Variation to DA 020/0003/14A

203 North Terrace, Adelaide

Development Authorisation 020/0003/14A Variation 1 - Internal works and changes to the southern façade affecting a State Heritage item

33-17640 A-0201 C

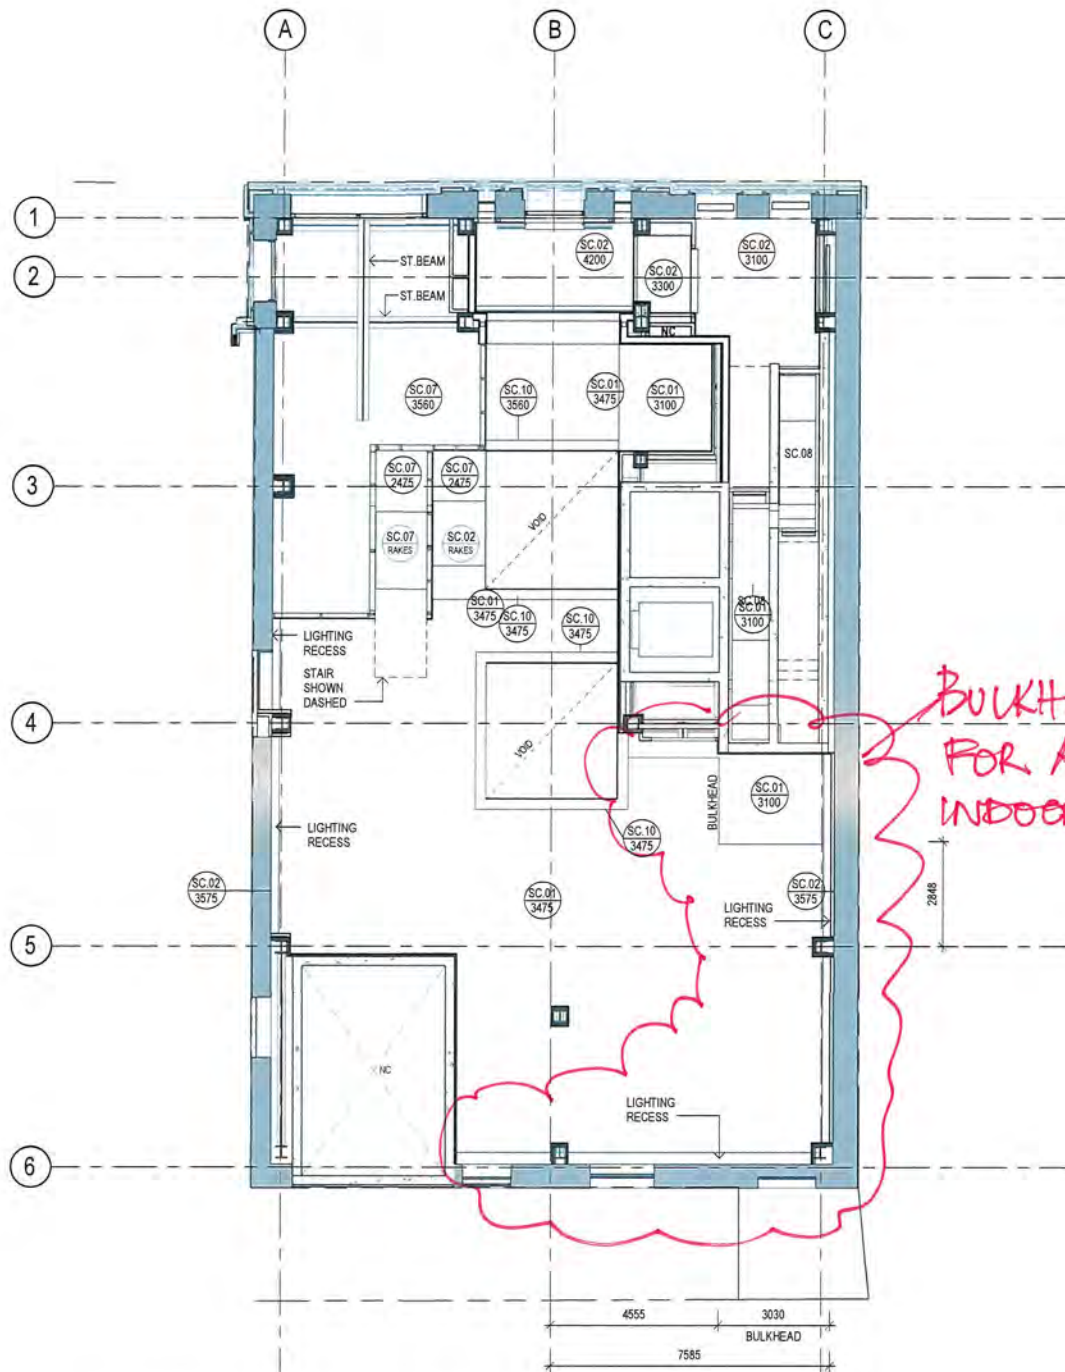
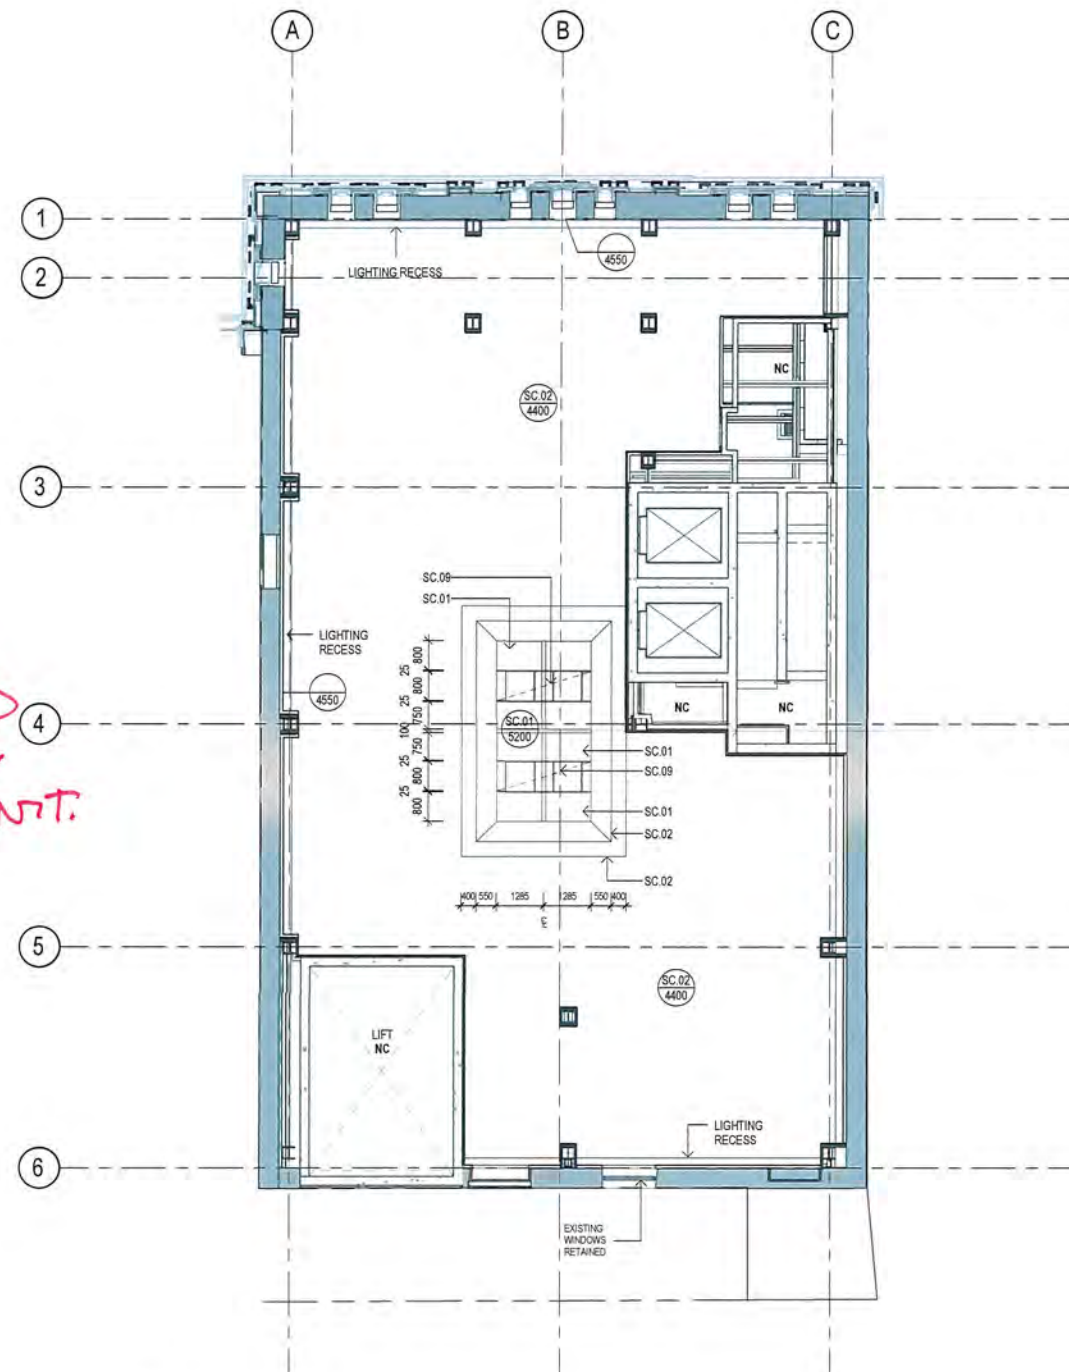
In order to make provision for future exhaust and mechanical fit out within the Ground floor. See drawings 33-17640 A-0201 ceiling plan and 33-17640 A-0403 south elevation. A drop ceiling is proposed just south of the lift core to accommodate the air conditioning unit which is being installed as part of the base build works. This zone will also be utilized for amenities on L1 as part of any future tenancy leasing negotiations.

- The new Level 1 steel support structure is arranged in such a way to simulate the old bearer locations, height and proportions. The concrete slab spans between these main members (refer structural layout WAD121048 S1.20). The timber matchboard lining is applied under a line of fire rated plasterboard, a building rules requirement to protect the base structure. The plasterboard is exposed to express the shape of the bearers (ceiling plan 33-17640 A-0201, detailed 33-17640 A-0656)

33-17640 A-0403 C

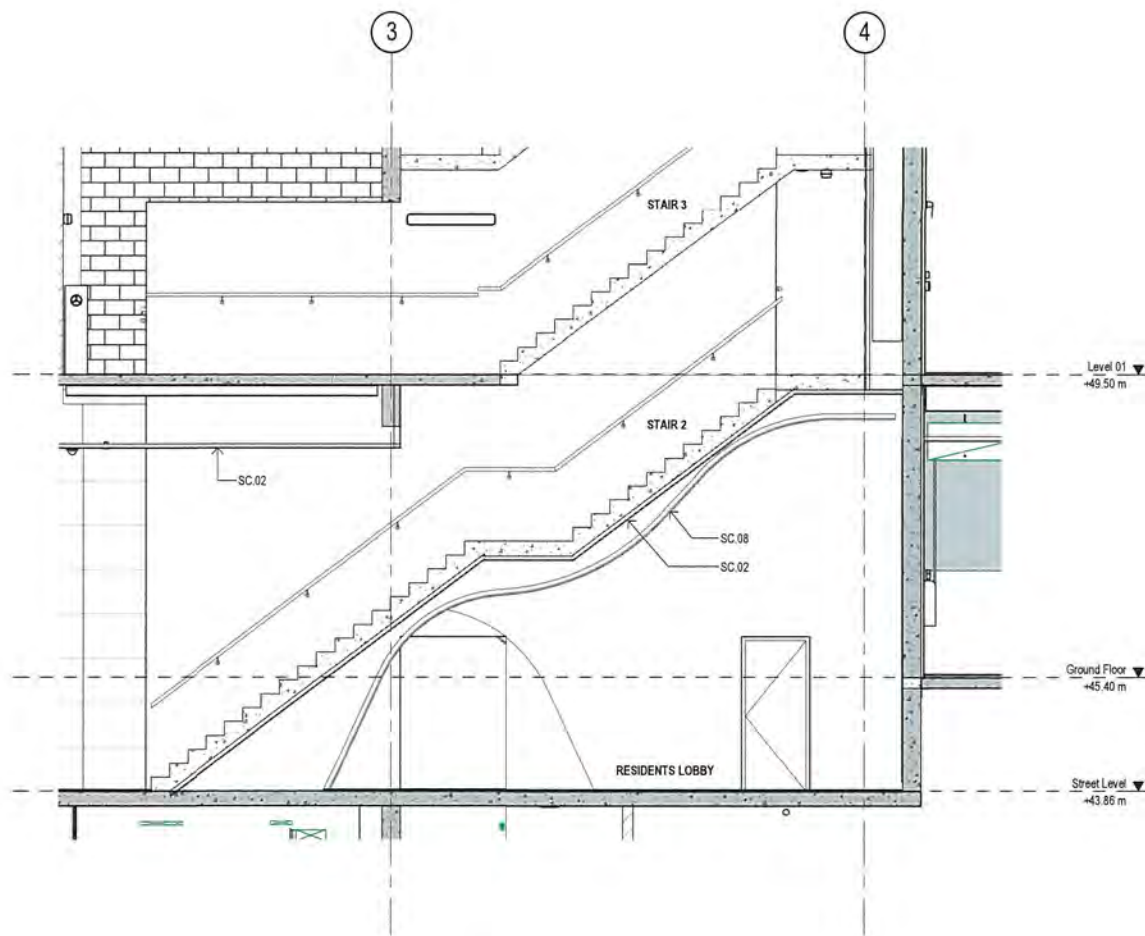
See attached drawings 33-17640 A-0403 and detail on 33-17640 A-0677 with the lift shaft texture painted and the edge of stonework expressed with repaired and repointed stone dowelled into the new concrete shaft. Note that the site title boundary to the light well easement is concurrent with the southern edge of the wall thus limiting any ability to overhang the lift shaft beyond the stone face.

Support subject to a condition requiring further detail. *The southern wall is contained within a light well with very limited visibility. The removal of a vertical strip of the wall to allow re-alignment of the car lift would have no impact on the architectural values of the place, and its impact on the representational values of the place as a warehouse would be minor.*

Prior to commencement of works to remove a section of the southern wall to accommodate the car lift shaft, details of the following particulars shall be submitted to the satisfaction of the planning authority in consultation with the State Heritage Unit (Department of Environment, Water and Natural Resources).
